Technical Service Bulletin

FRONT DIFFERENTIAL OIL LEAK FROM OIL SEAL (RH SIDE)

Bulletin No.: 03-001/24

Last Issued: 04/03/2024

[How to apply grease to engine oil pan]

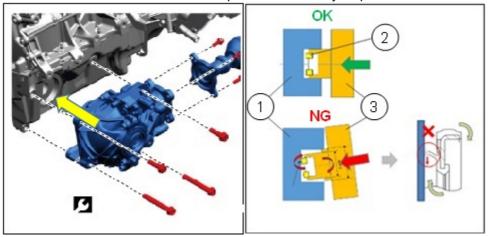
7. Apply a small amount of grease to the engine oil pan surface with the front differential.

- Any one of the three options of grease listed below can be used (or an equivalent).
- This procedure is to prevent deformation of the differential oil seal lip during installation.

- (1) Put small amount of grease on your finger.
- (2) Apply a thin layer of grease all around.
